Subj: Additional Information regarding Commonwealth Edison Company's
Response to Questions Regarding the Increase in the
Interim Plugging Criteria for
Byron Unit 1 and Braidwood Unit 1
NRC Docket Numbers: 50-454 and 50-456

REQUEST FOR ADDITIONAL INFORMATION
REGARDING THE PROPOSED REVISIONS TO THE TECHNICAL SPECIFICATIONS
RELATED TO THE STEAM GENERATOR TUBE VOLTAGE-BASED REPAIR CRITERIA
BYRON, UNIT 1, AND BRAIDWOOD, UNIT 1
DOCKET NOS. STN 50-454 AND STN 40-456

Figure 54-1: Axial Rupture Force vs. Bobbin Amplitude
 Data Adjusted to 3/4" x 0.043" SG Alloy 600 MA Tubes, $S_r = 75$ ksi

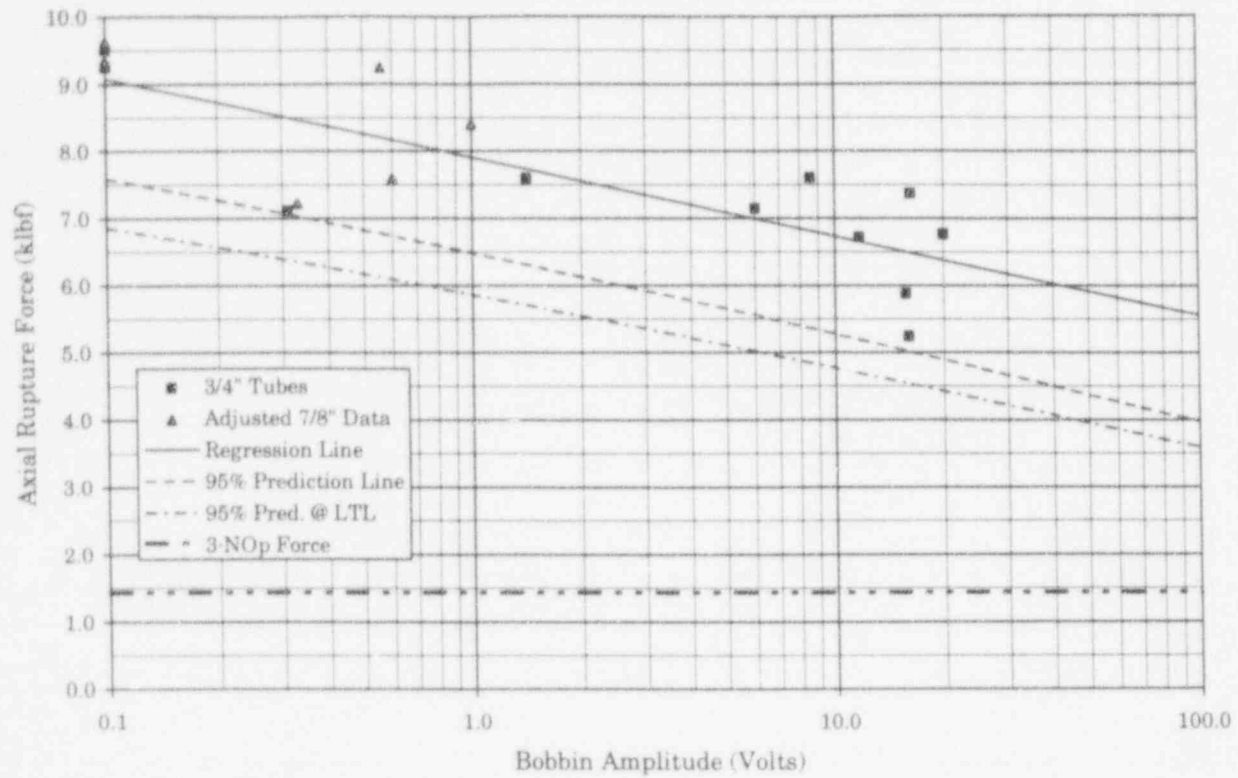
Provide a plot of the axial force required to fail a SG tube versus the bobbin voltage for those SG tube specimens which were tensile tested. Provide a discussion of the material properties adjustments made to the data, if any. Discuss how the lower tolerance limit material properties curve was developed in Figure 41-1 given that both 3/4-inch and 7/8-inch data are used. The staff notes that the residual SG tube cross-sectional area may vary with the axial elevation of the degradation. For the correlation in Figure 41-1, discuss how the appropriate residual cross-sectional area was determined (i.e., the location where the circumferential severance is postulated to occur).

The results of the regression analysis are provided in Table 54-3 and illustrated on Figure 54-1. In summary, the axial rupture force in thousands of pounds, klbs, can be reliably predicted from the bobbin amplitude as,

Using the above equation, a 95% one-sided prediction bound for the rupture force as a function of bobbin amplitude was calculated. The resulting curve was also adjusted to represent 95/95 lower tolerance limit (LTL) material properties. Both of these curves are also depicted on Figure 54-1. It is apparent that the structural limit obtained from this analysis approach is in excess of 100 volts.
